Fourth Inspection Report  
of the  
New England Power Company  
Deerfield River Project  
Harriman and Sherman Developments  
Project No. 2323  
June 1982

Inspection and Report  
by  
CHAS. T. MAIN, INC.

SUBJECT: Fourth Inspection Report  
New England Power Company  
Deerfield River Project  
Harriman and Sherman Developments  
Project No. 2323

Photo No. 3  
Interior of Glory Hole Spillway  
Note Foundation/Concrete  
Lining Drain Flow

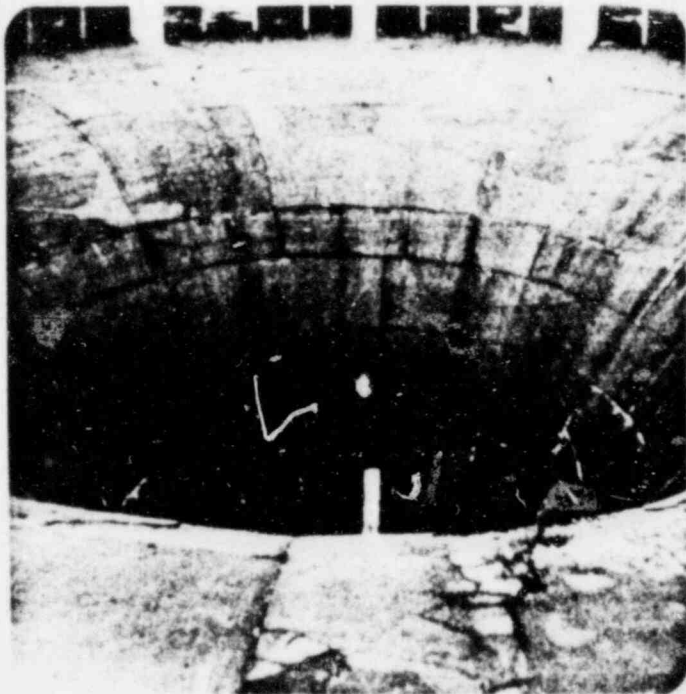
The glory hole spillway surface appears generally in good condition, with the exception of the southeast quadrant where significant spalling has occurred. The relief drain outfall on the north side of the spillway throat (elevation 1375) appears to operate in excellent fashion. This detail consists of a box drain around the throat liner with drill holes into the bedrock. The rock face south of the spillway is heavily fractured and shows potential for large blocks of loose rock to fall toward the glory hole. Periodic inspections should be made of this area as in the past to note any unsafe conditions and removal of same, if necessary. The structural steel painting and surface treatment of walkway timbers all appear in generally good condition, with only very minor touchup or repair needed.

Photo No. 7  
Powerhouse Wall Above Draft Tubes  
Note Seepage and Stains

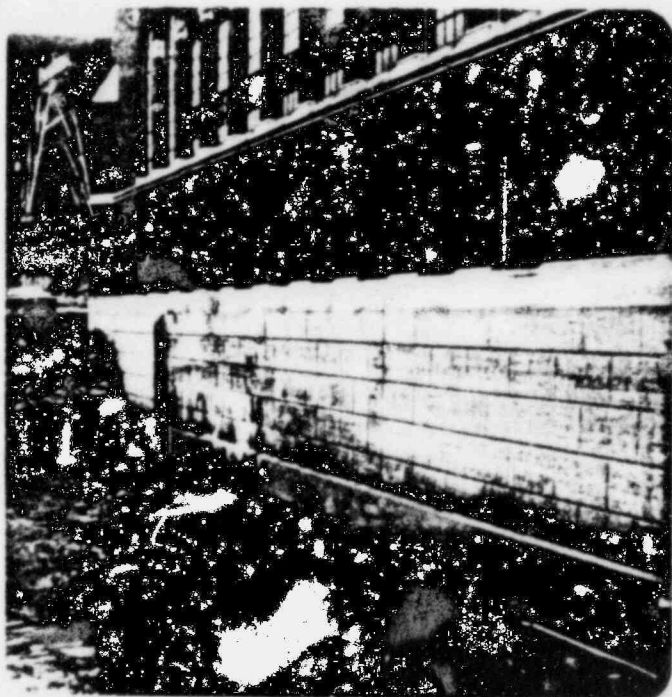
The exterior brickwork remains in excellent condition, while the left downstream lower wall (concrete) has craze cracking on its face. A calcite joint over Unit 3 tailrace shows some concrete deterioration.

Photo No. 1  
Lower Spillway  
Note Rock Jointing

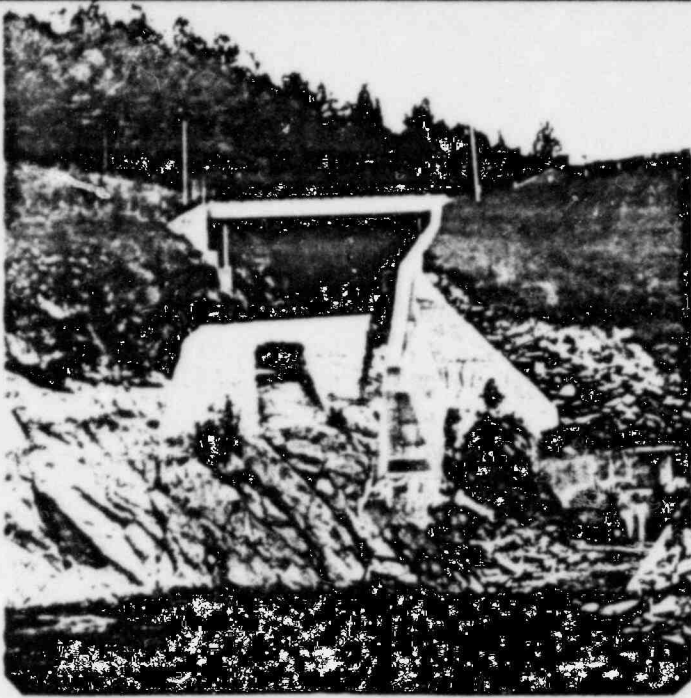
The flashboards on the spillway remain tight, while the mass concrete and lift joints appear in good condition. Rock in the spillway channel, though jointed, appears in generally good condition. Some surficial erosion of the right downstream slope has occurred, but does not present a problem.
